Minutes

SMPAC Travel Lane Widths Work Group Session

Meeting Date & Time: Thursday, June 1, 2023
10:30 a.m. – 12:00 p.m.

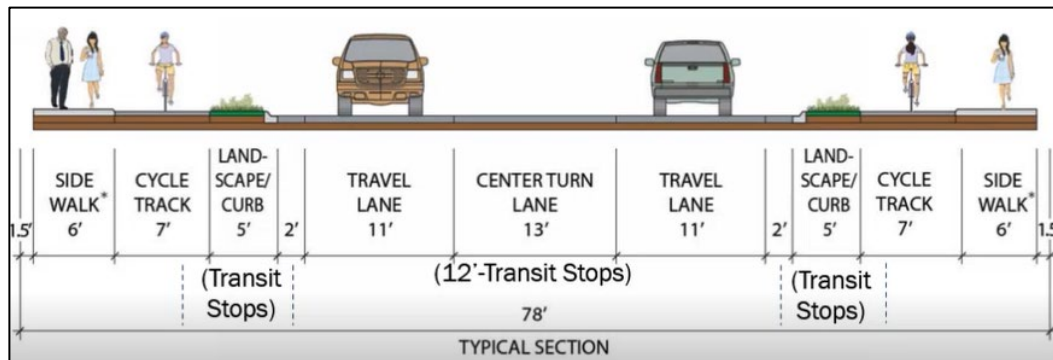
Mark Gibson asked if it is correct that the Design Concurrence Document does not ask if the route is a designated freight route. Rich said that is correct. He said the form does ask if the route is a Reduction Review Route. Mark asked if all designated freight routes are considered Reduction Review Routes as per the Oregon Highway Plan. Mike Kimlinger said most are, but not all of them. Mike said it's a good point, and that ODOT should consider adding extra language to the form regarding freight routes to provide more context.

Walt Gamble commented that the Travelway Realm text box on the Concurrence Document does not mention that we need to assume a 11-foot lane will help the project reach its target speed. Rich said that is part of the general discussion, and that this slide just shows an example of how the design decisions are documented.
